Customer Product Information (CPI)

PN21-046 **Erratum of SEMIPONT4 datasheet** 28 May 2021

Subject of change: Correction of module drawing and product picture

SEMIKRON SEMIPONT 4 modules

Product picture - current datasheet	Product picture - new datasheet
SCHILDIN STATE STA	SEMPONTA SERVICIONAL SERVICION

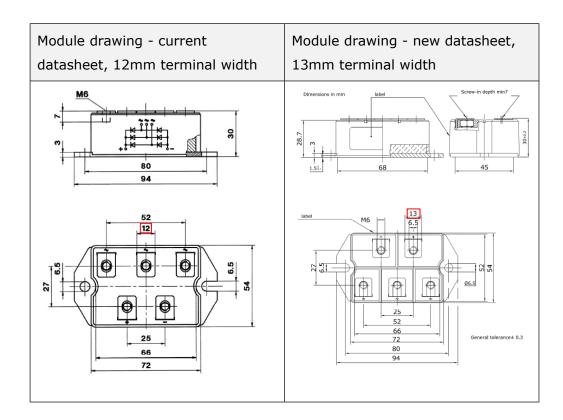
Erratum of the module drawing and the product picture in the datasheet. The terminal width in the drawing was corrected from 12mm to 13mm.

Reason for change: Incorrect product picture and module drawing
